**Economic Commission for Europe****Inland Transport Committee****World Forum for Harmonization of Vehicle Regulations****156<sup>th</sup> session**

**1958 Agreement – Consideration of draft amendments  
to existing Regulations submitted by GRE****Proposal for Supplement 18 to Regulation No. 23 (Reversing  
lamps)****Submitted by the Working Party on Lighting and Light-Signalling \***

Figure 4  
**Marking for a manoeuvring lamps**

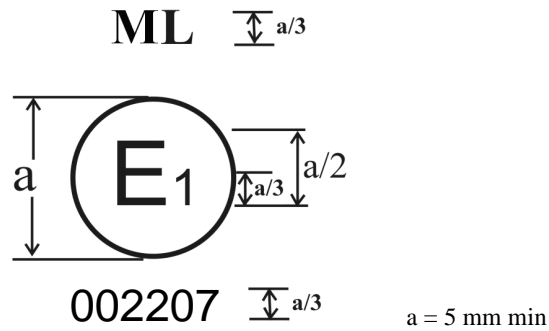
Annex 2, amend to read:

The device bearing the approval mark shown above is a manoeuvring lamp approved in Germany (E1) pursuant to Regulation No. 23 under approval number 2207.

The approval number indicates that the approval was granted in accordance with the requirements of Regulation No. 23 in its original form.
